Subject: Workplan Revisions
3635 13th Avenue
Oakland, California
Fuel Leak Case No. RO0000159
AEI Project No. 110803

PROPOSED BORING AND WELL LOCATIONS

3635 13th Avenue
 Oakland, California

FIGURE 1
 AEI Project # 110803

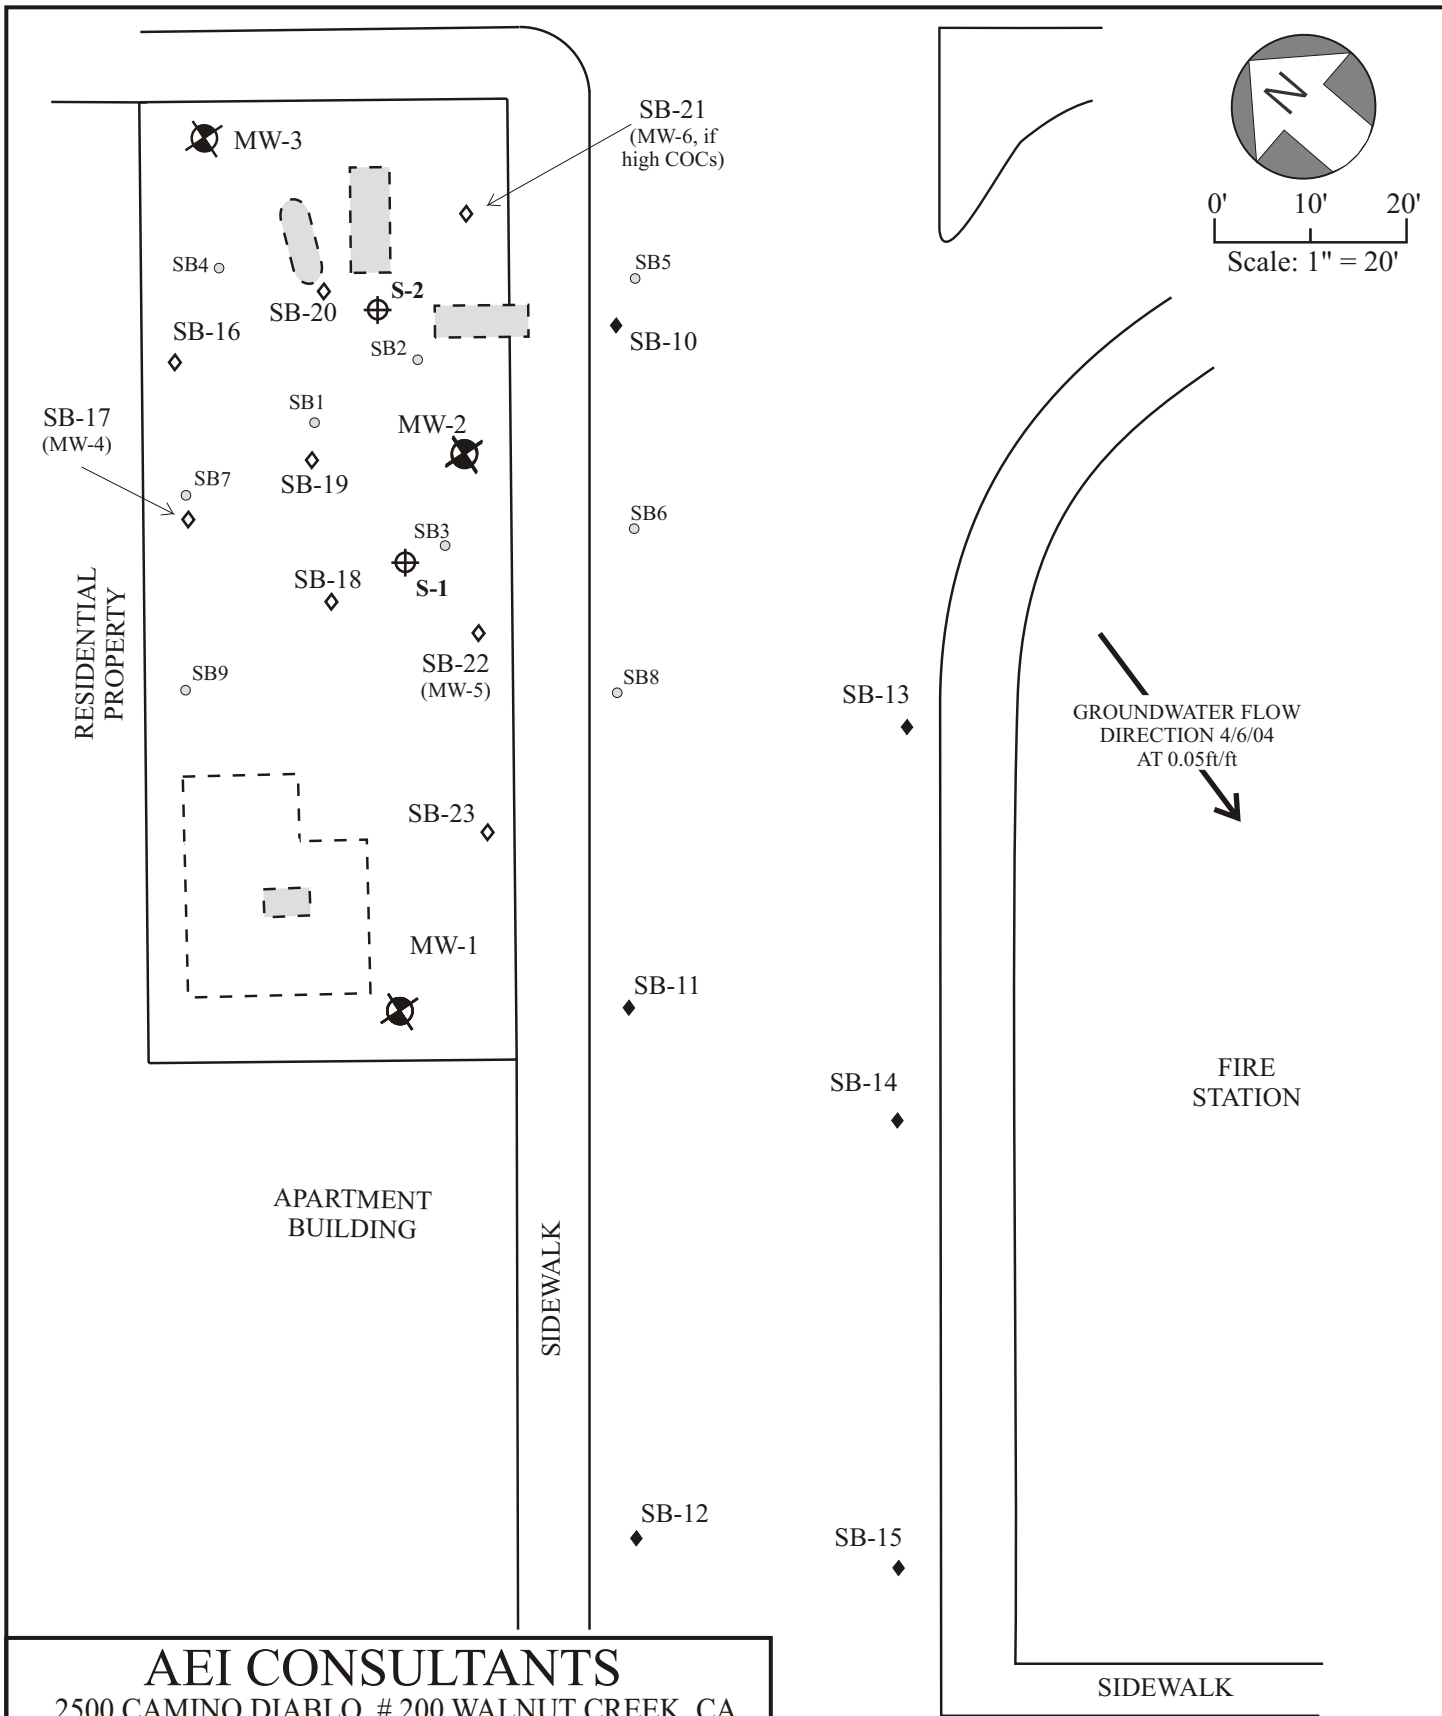
1. Soil borings will be continuously cored using direct push drilling methods. Soil samples will be logged and field screened in accordance with the ACEH comments, which are consistent with the methods outlined in the 2004 plan. Samples will be selected at depths of apparent impact, elevated PID readings, and to identify the bottom depth of impacted soil. We concur with the suggestion to sample an additional soil boring in the location suggested by ACEH, between boring SB-22 and existing well MW-1. This additional boring (labeled SB-23) is shown on the attached figure.

Two additional monitoring wells (MW-4 and MW-5) and possibly a third (MW-6) have been proposed. These wells will be constructed with a short (no more than 5 foot) screen and sand section. The exact interval will be based on the logs of the borings and results of soil and groundwater sample analyses. In order to adequately evaluate the findings from the soil boring work (SB-16 to SB-23), well installation activities will be scheduled several weeks after the soil borings. If boring logs provide justification for screen lengths greater than 10 feet, ACEH will be contacted with such information prior to well installation.

7. Locations of the proposed sparge wells (S-1 and S-2) were selected to be in areas indicated by previous investigations as having high concentrations of residual pollution and sufficiently close to either existing or proposed monitoring wells to evaluate the effectiveness of the proposed approach. AEI agrees that moving S-2 closer to MW-2 could provide quicker evidence of contaminant reduction. As additional investigation will be performed and the site conceptual model refined, modifications to the interim corrective action approach, including sparge well locations, will be including in the requested Soil and Groundwater Investigation Report (SWI).
